CHANGE ORDER NO. 11

PROJECT: West Sewage Treatment Plant (STP) Improvements  
 OWNER: City of Crest Hill, Illinois  
 CONTRACT: 1-2022  
 CONTRACTOR: Vissering Construction Company

Project: CITY OF CREST HILL - WEST SEWAGE TREATMENT PLANT IMPROVEMENTS

Cost Proposal Request  
West Sewage Treatment Plant Improvements  
City of Crest Hill  
Contract 1-2022  
August 26, 2025

SHEET  
175  
E70-ASM1.02

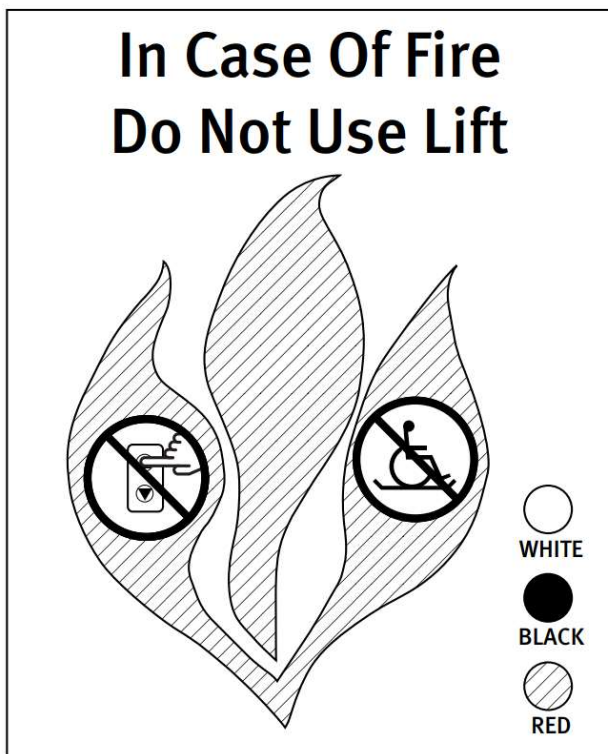
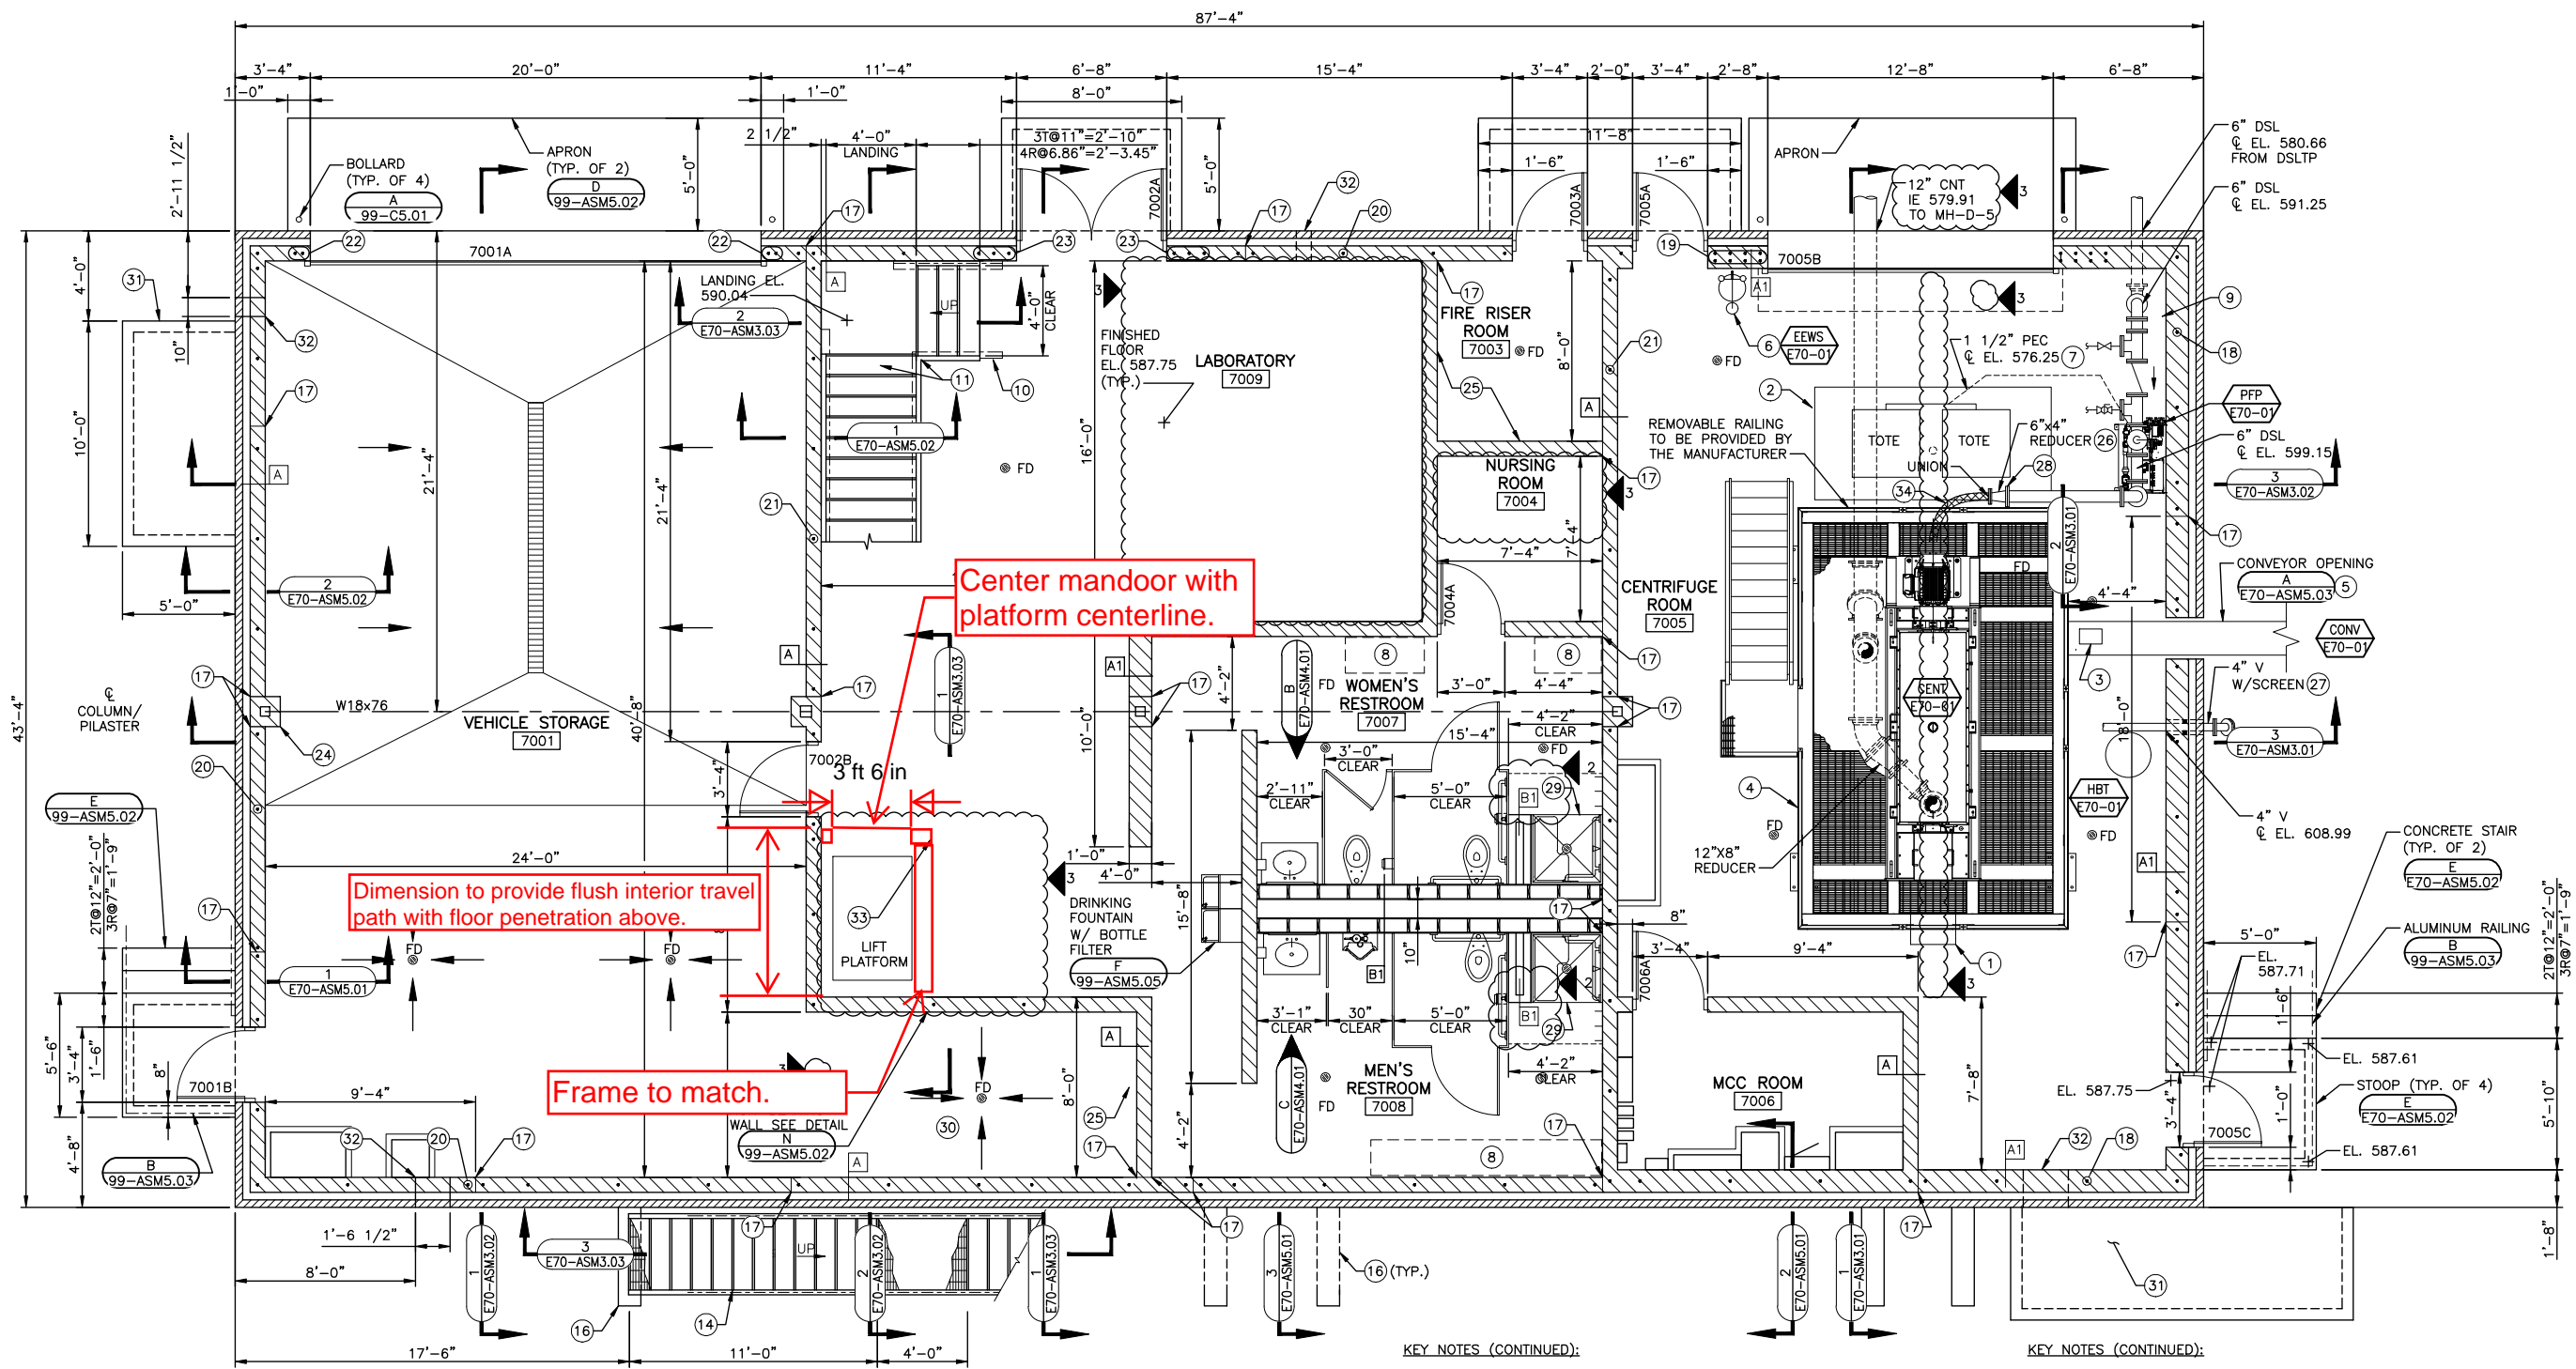
**Drawing E70-ASM1.02**

- 044-04 Frame northern shaft fenestration on second floor. See attached drawing. Standard manufacturer-provided door, its respective wiring, and call-station shall remain at the second floor.

**SHEET**  
174  
**E70-ASM1.01**

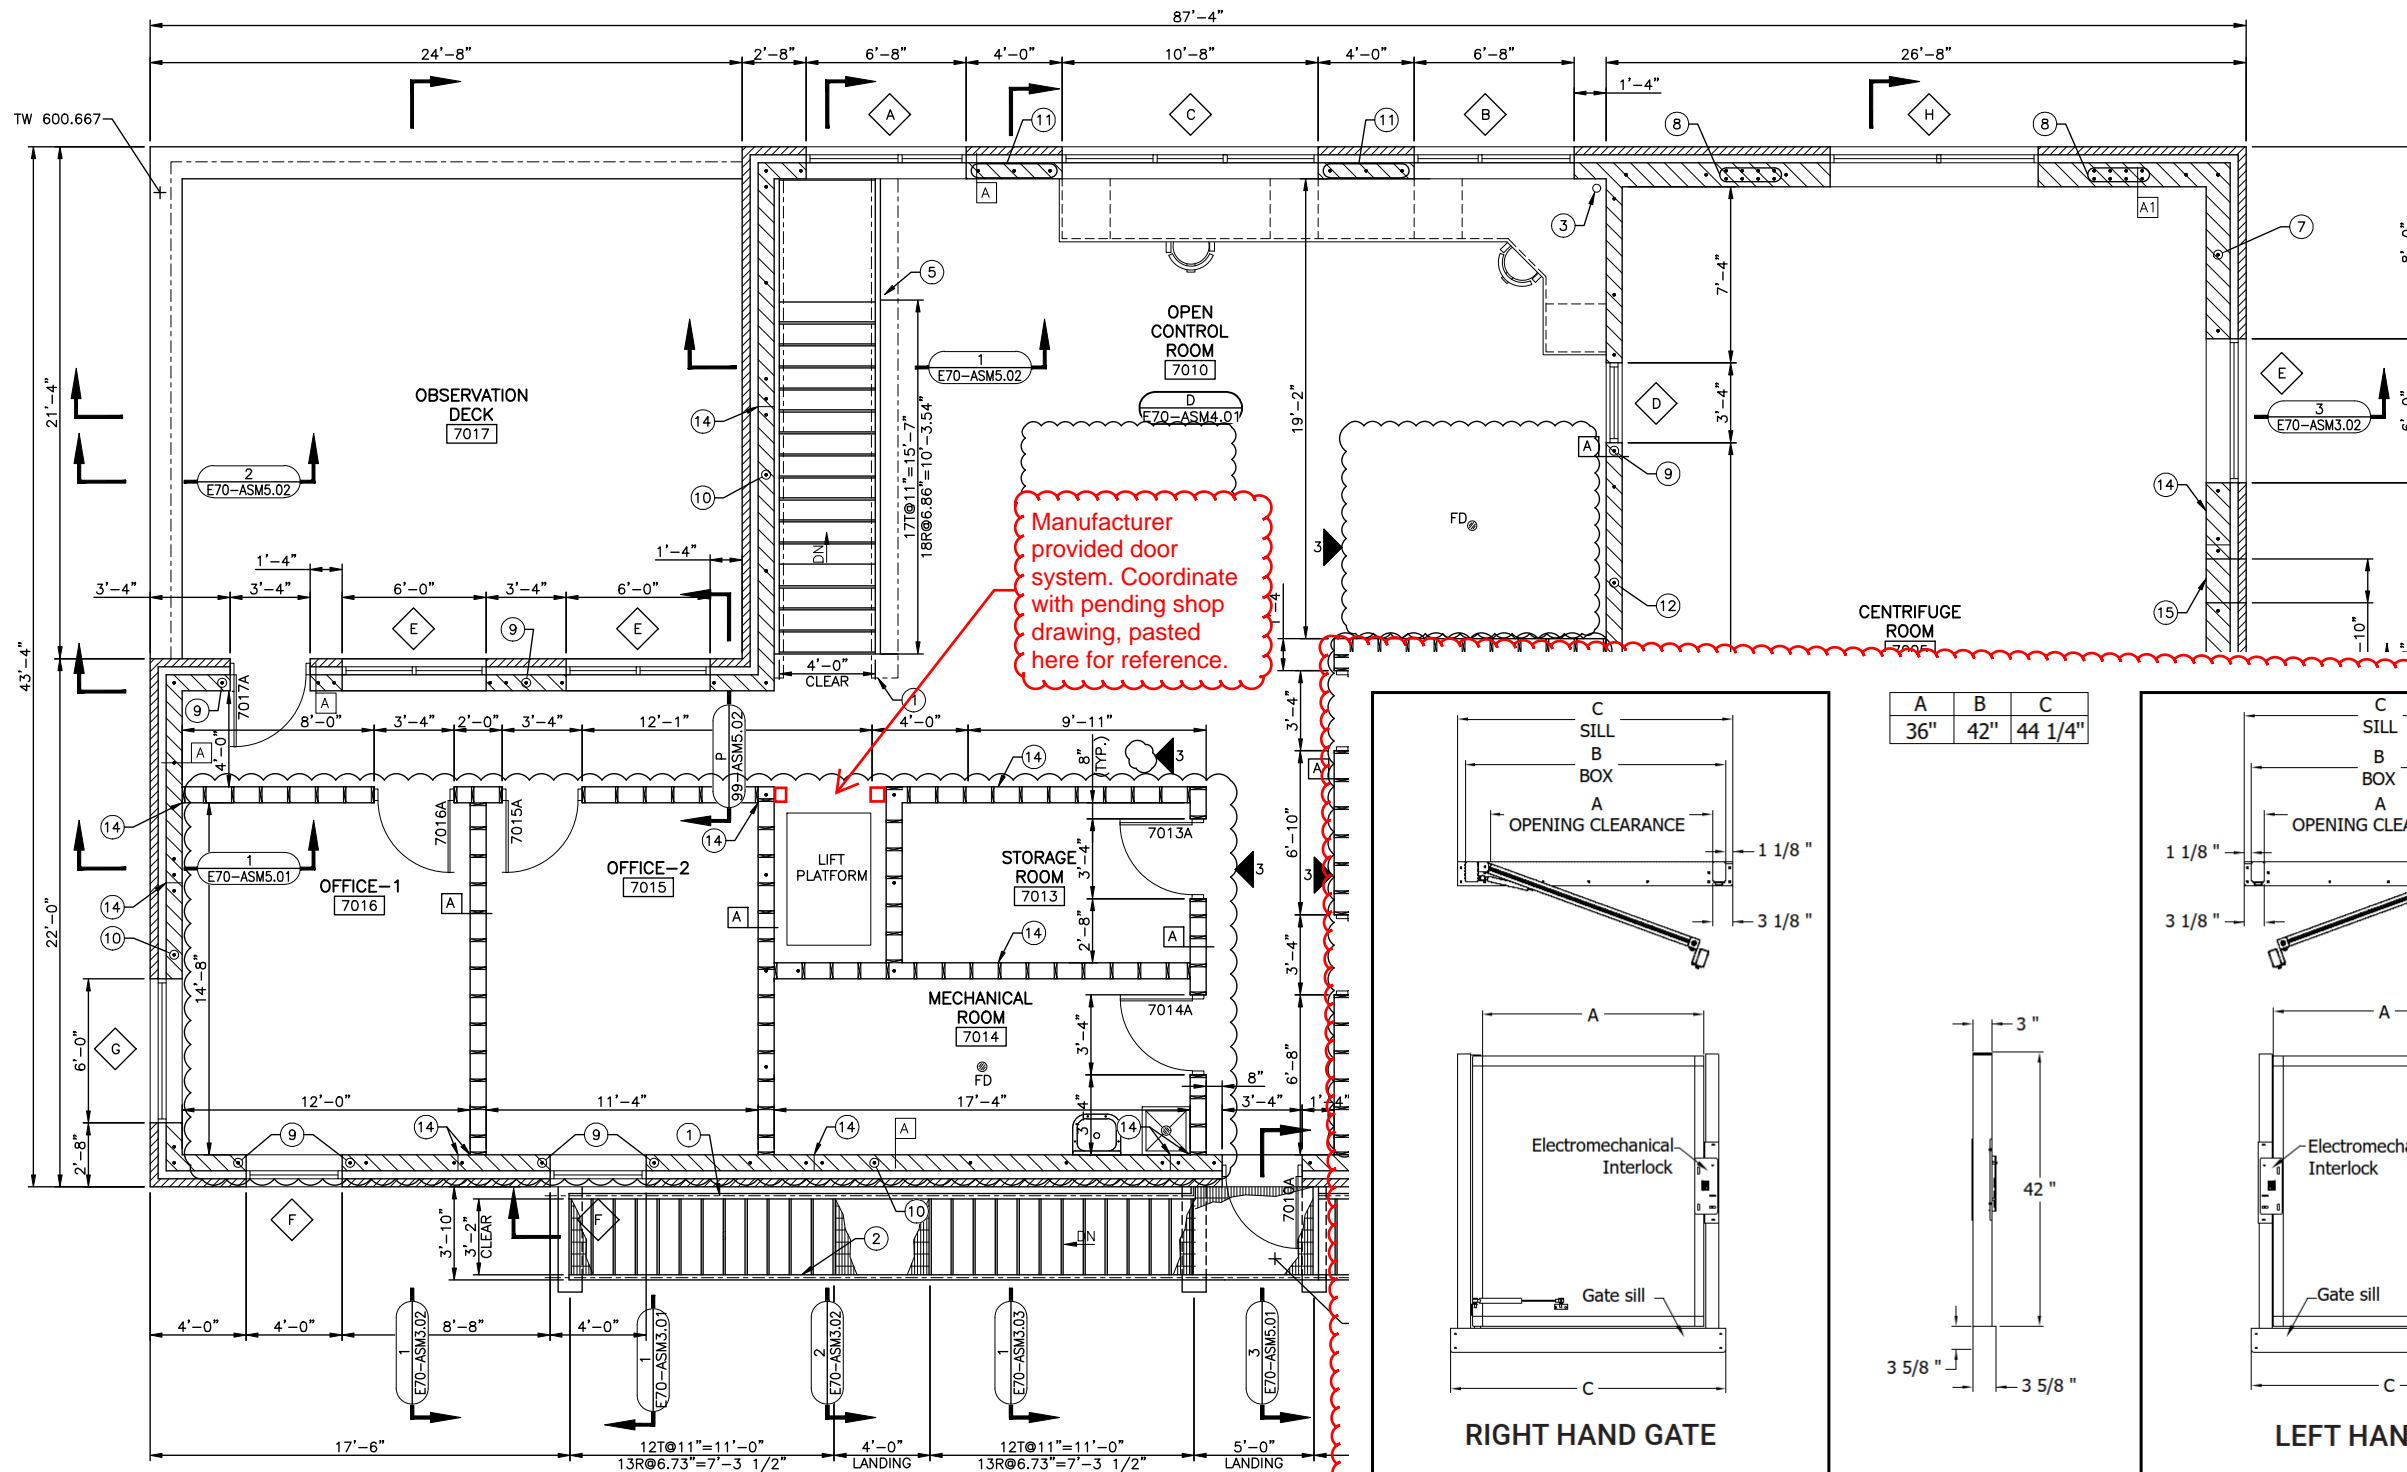
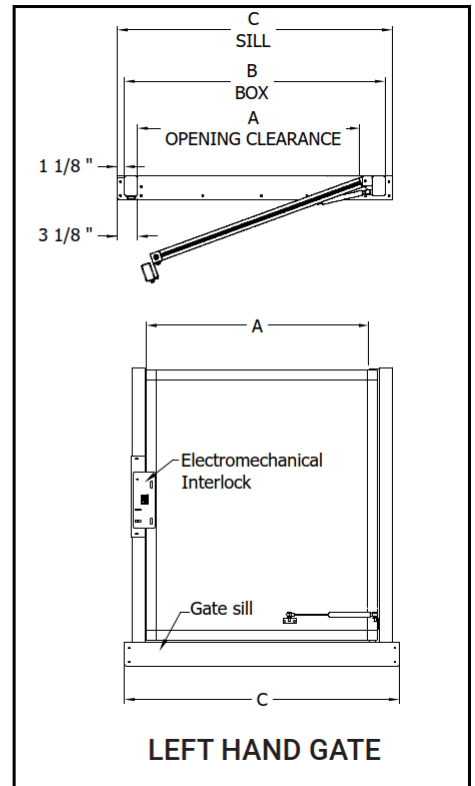
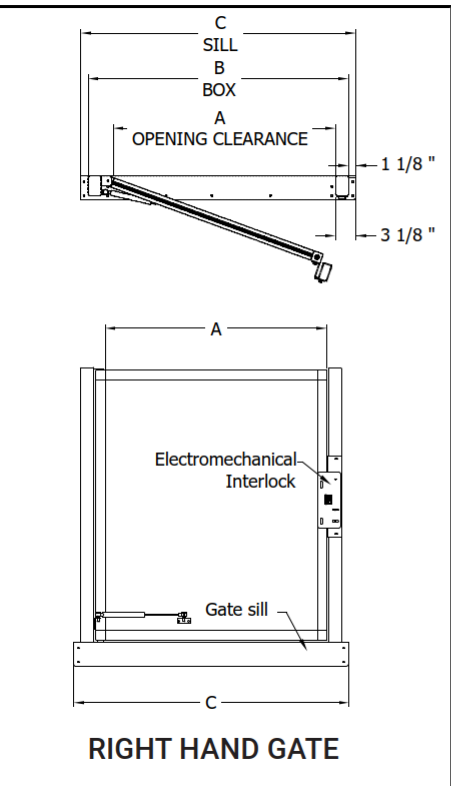
**Drawing E70-ASM1.01**

- 044-01 Frame and drywall the northern and eastern shaft fenestration surrounding the newly proposed door on the first floor. See attached drawing.
- 044-02 Change manufacturer provided first-floor half-height door with full height mandoor. Rewire electrical componentry from manufacturer-provided call-station to interlock doorway hardware (automatic door opener) with platform lift system operation, as described below.
- Add row to Drawing 99-ASM6.01 Door 7002C, size 3'-6" x 7'-0", type - STL, active - HG, swing - RHR, frame type - 1, frame material - STL, hardware group - as provided by product manufacturer, active, lintel - B-1, Details, head - F-99-ASM6.02, jamb - F-99-ASM6.02, sill - N/A
- 044-03 Provide attached pictograph (Attachment A) at first floor and second floor call stations. Pictograph shall conform to Section 10 14 00 - Plastic and Metal Signs.
